Motorola Mobility LLC.

Product Equality Declaration

We, Motorola Mobility LLC, declare on our sole responsibility for the product as below:
The differences between EMEA DS and previous as below:

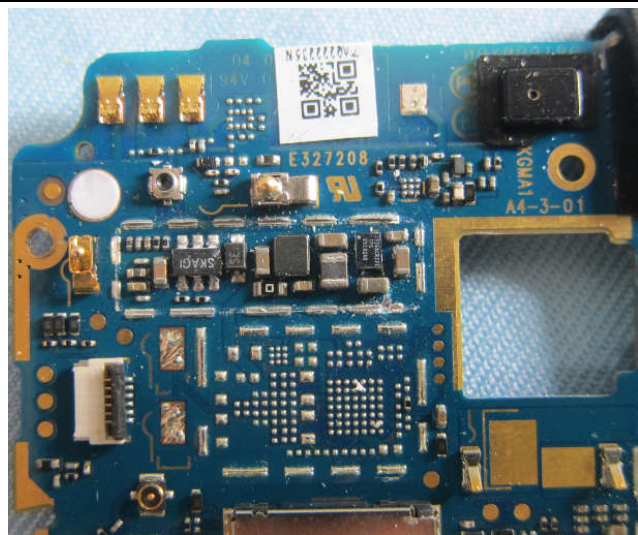
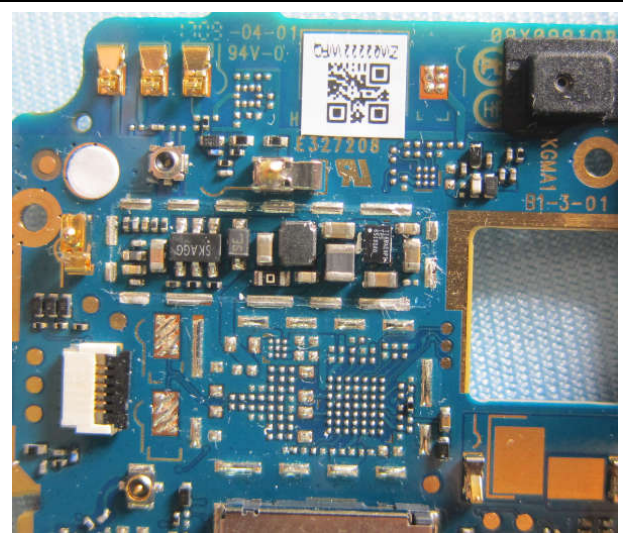
Previous: Manual to remove SAR Sensor Chip and SAR Sensor shrapnel;

Current: Optimizing the BOM patch and removing the Sar sensor and its matching circuits.

These changes have no effect on RF.
